CITY OF ALBUQUERQUE

**RE: Lot 2 Block 10 Unit 18 Volcano Cliffs
6508 Picardia Pl. NW (S.A.D. 228)
Grading and Drainage Plan
Engineers Stamp Date 11/16/2020 (D10D0003P2)**

Based upon the information provided in your submittal received 11/16/2020, this plan cannot be approved for Grading Permit until the following comments are addressed.

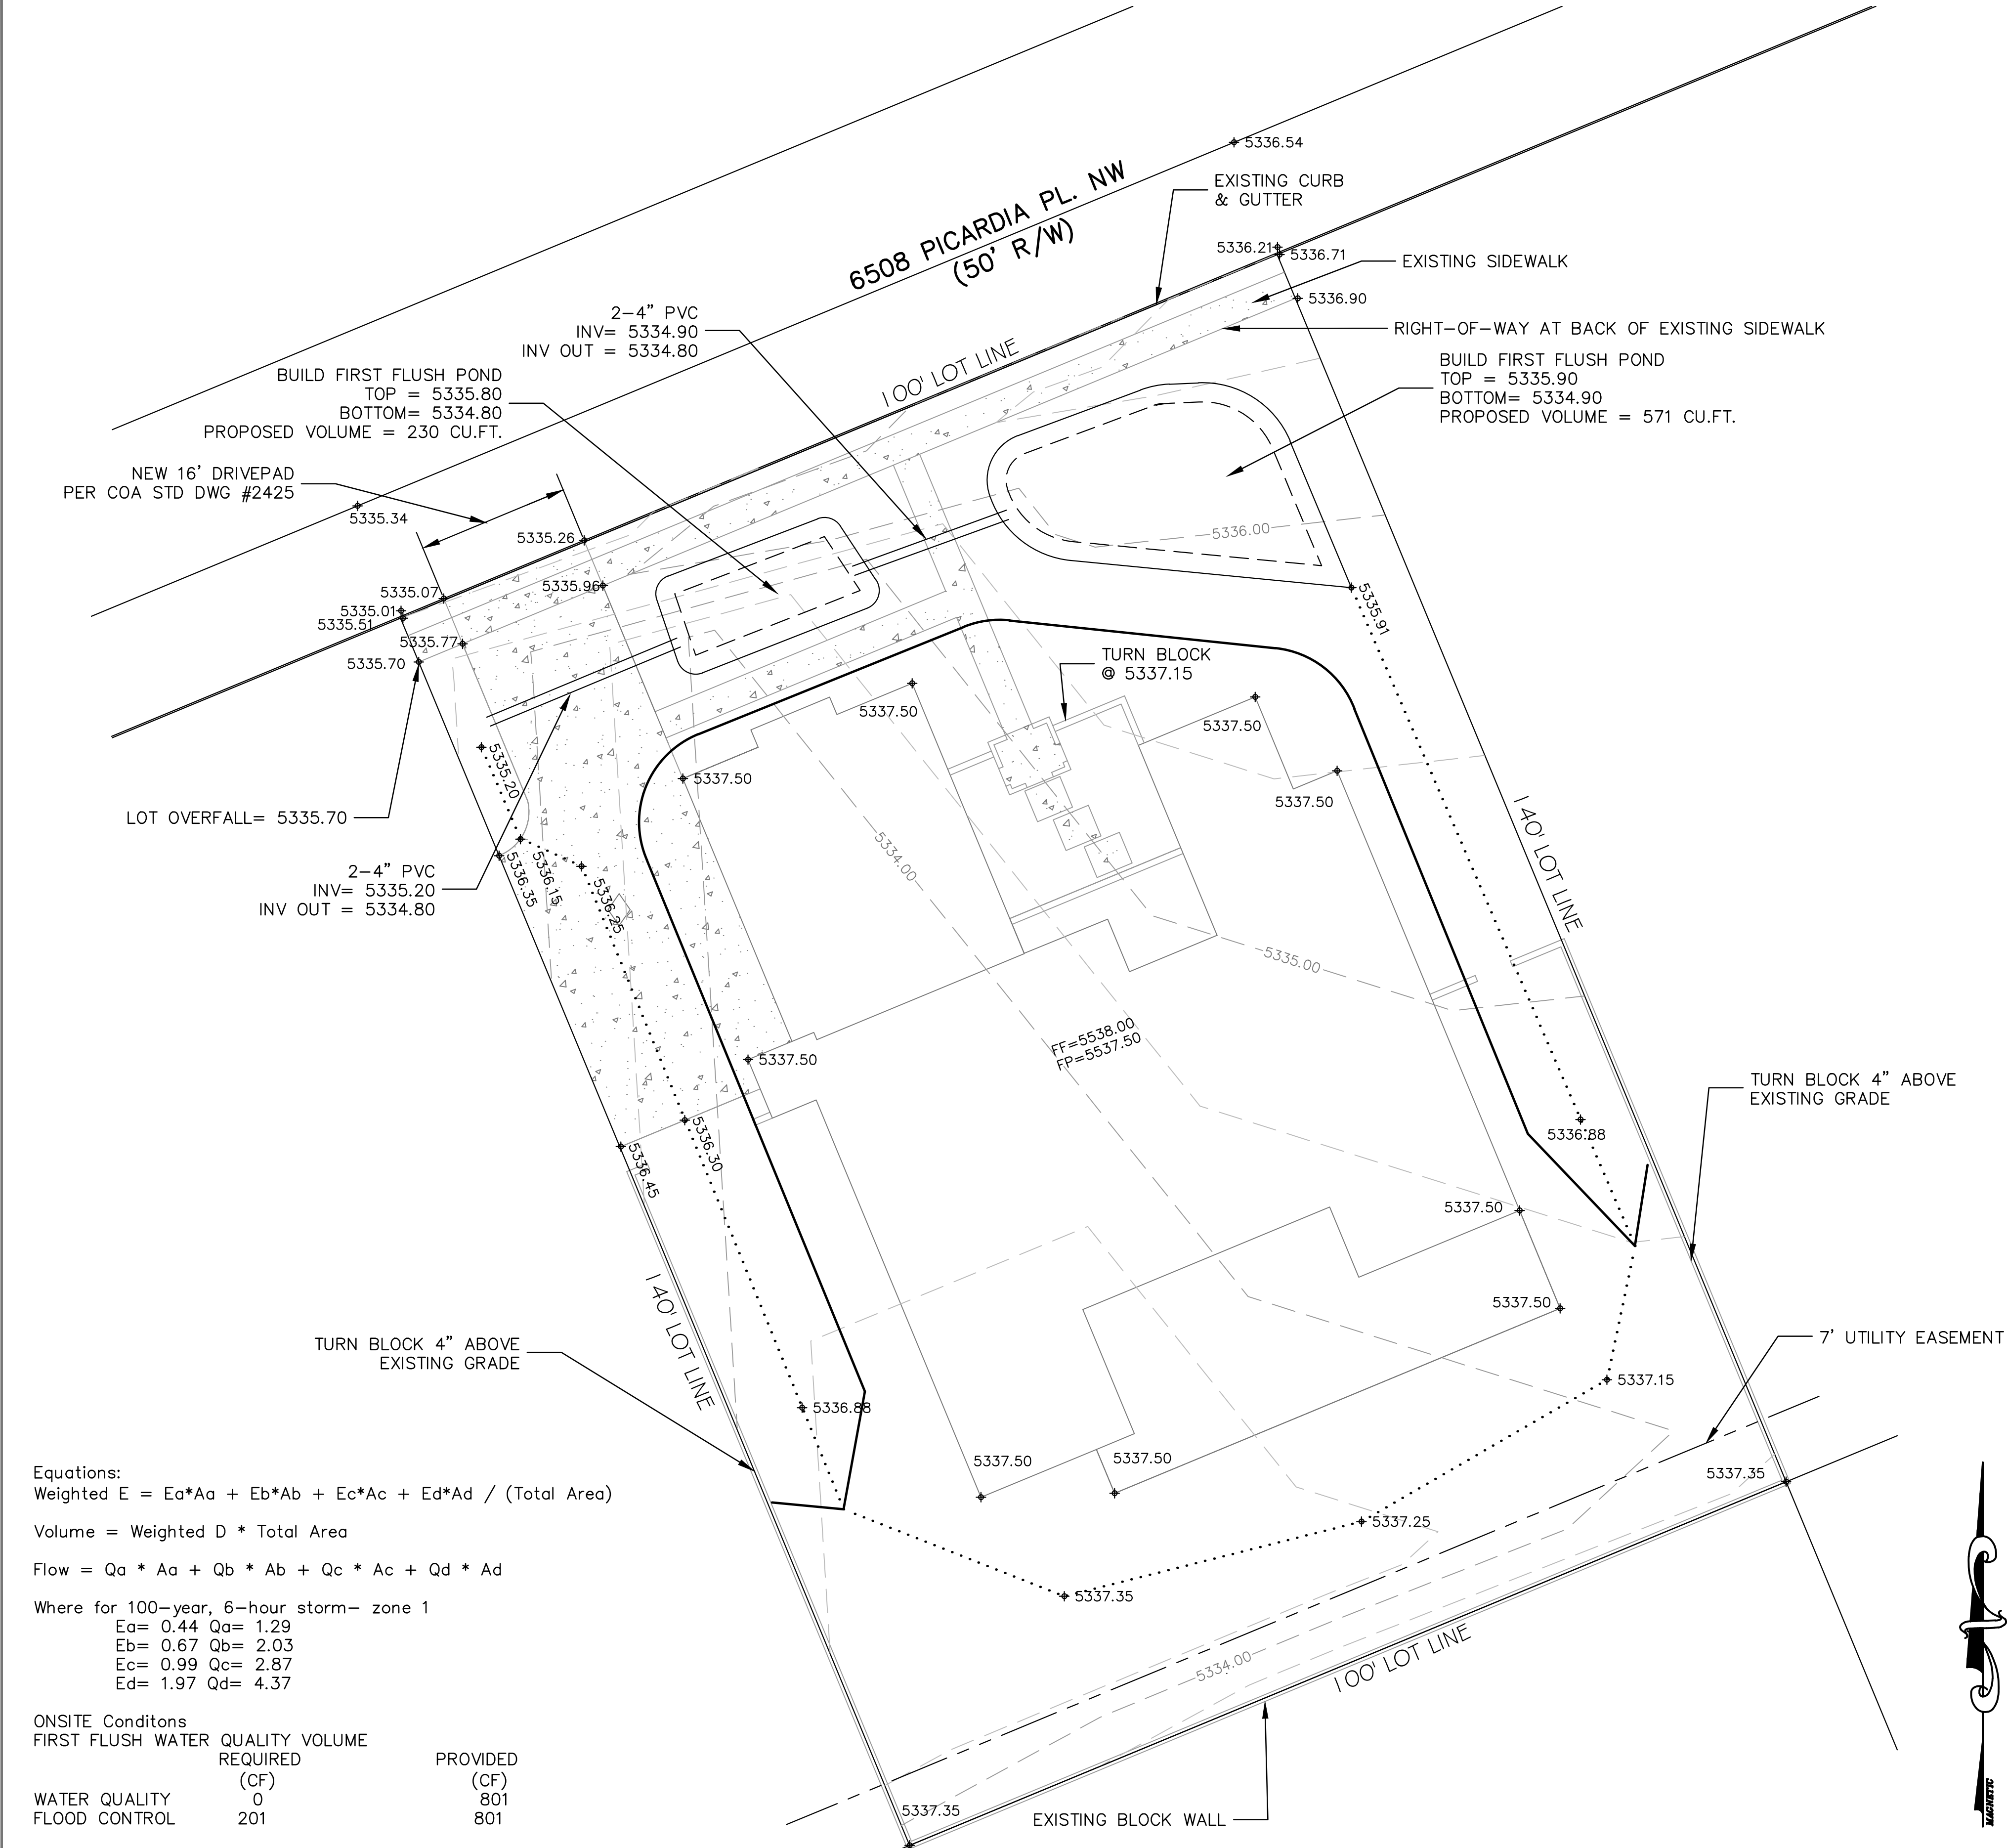
- PO Box 1293
- If a garden wall is built turn blocks should be provided 3" above finish grade.
 - The pad is too high, 6" above back of curb is sufficient; all flows need to drain to the backyard into the 7' PUE then easterly into the neighbor's yard. Ponding needs to be maintained in the PUE.
- Albuquerque
- All flows need to follow the SAD 228 Master Plan. This plan can be found in file number D10D003.
